# Policy Newsletter

## December 2025

## Major policy updates

### Standard Technique 8 – Resin Handling and Joint Shells

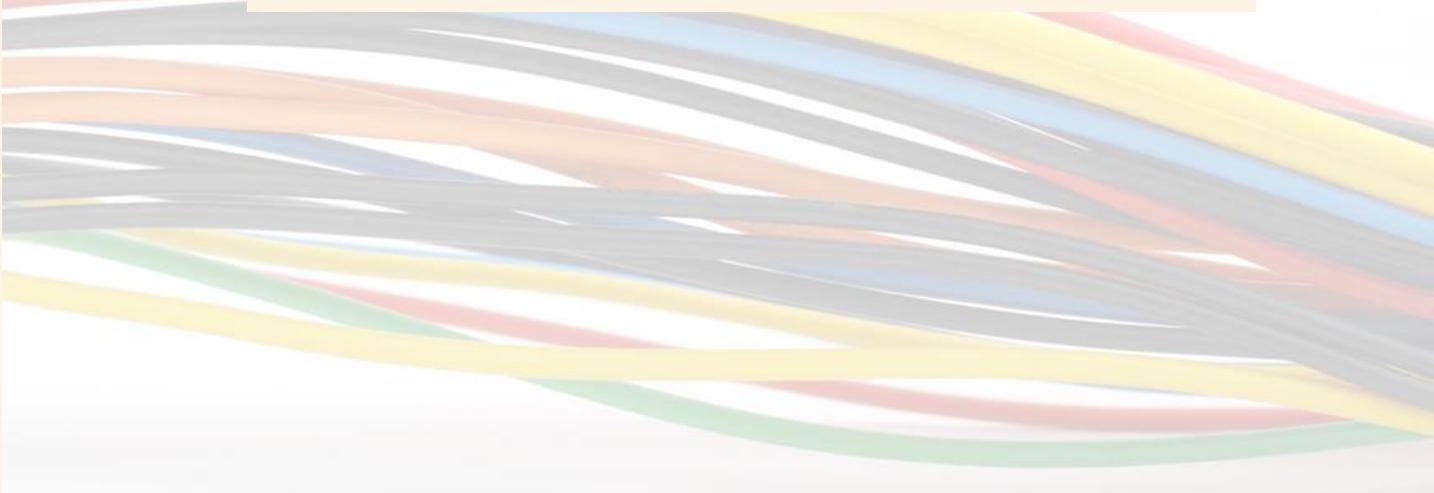
- New compostable bale bags added.

MT1 Waveform 3c Poletop Termination Issue 5

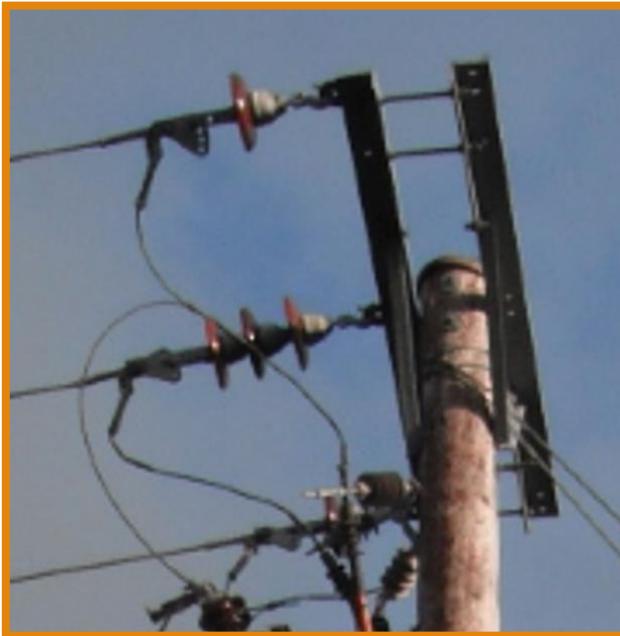
References to the 161161-bolt pack for 185mm<sup>2</sup> cables on kits supplied from December 2025 have been removed from both documents.
